STATION EQUIPMENT
JACKS, PLUGS, AND ADAPTERS
IDENTIFICATION, INSTALLATION, AND SERVICE

1.001 This addendum supplements Section 461-630-100, Issue 12. Place this pink sheet ahead of Page 1 of this section.

1.002 This Addendum is issued to add information on the **700A4** plug.

Fig. 27.1 — **700A4** Plug With Conductors Terminated

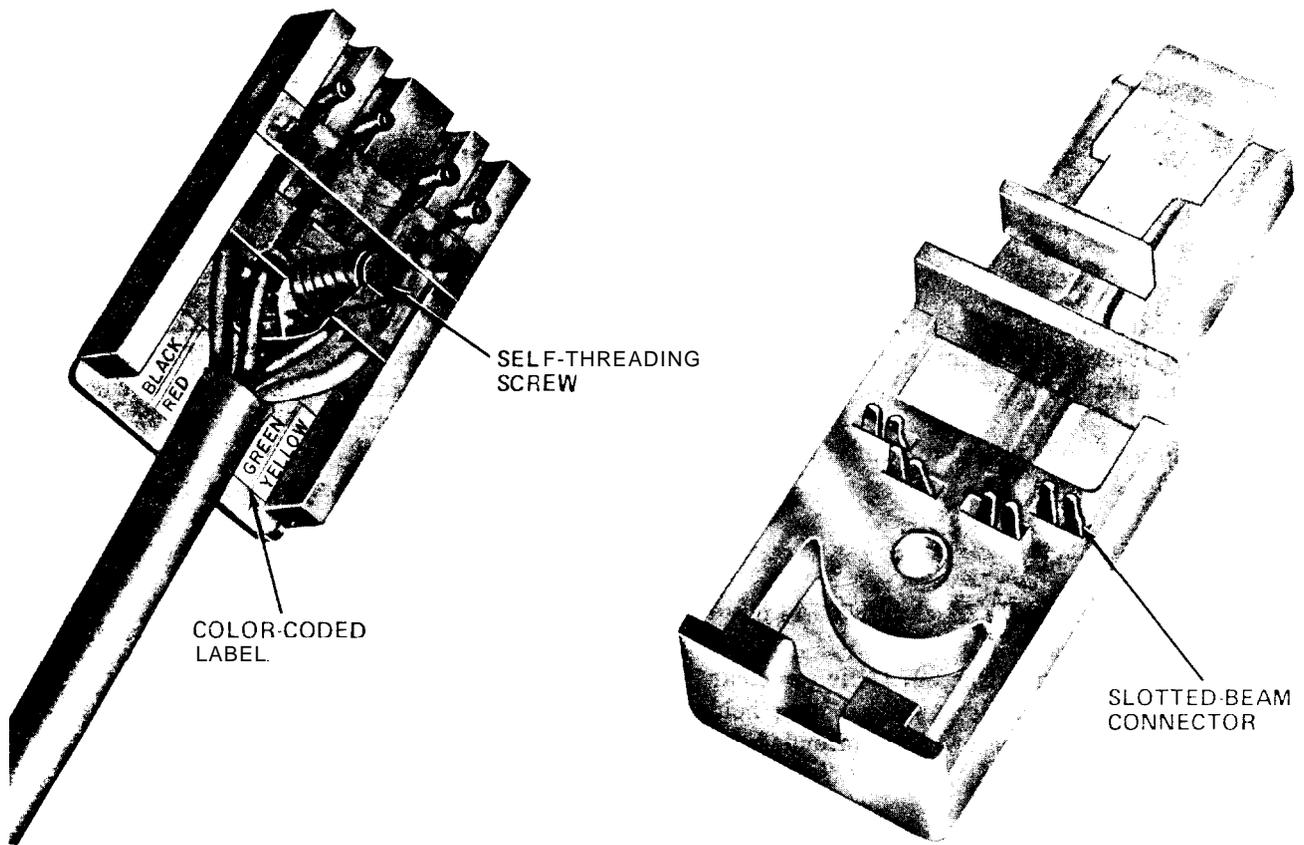
2.21.1 The **700A4** plug (Fig. 27.1) is a clear polycarbonate two-piece molded plug held together by a self-tapping screw. It is intended for

use at one end of a length of quad station wire to permit it to be plugged into a modular telephone jack. The contacts of the plug are connected to four slotted-beam connectors which will be forced through the insulation of the individual conductors when they are properly aligned and the sections screwed together.

2.002 On Page 15, paragraph 2.49 add Fig. 27.1 **700A4** Plug.
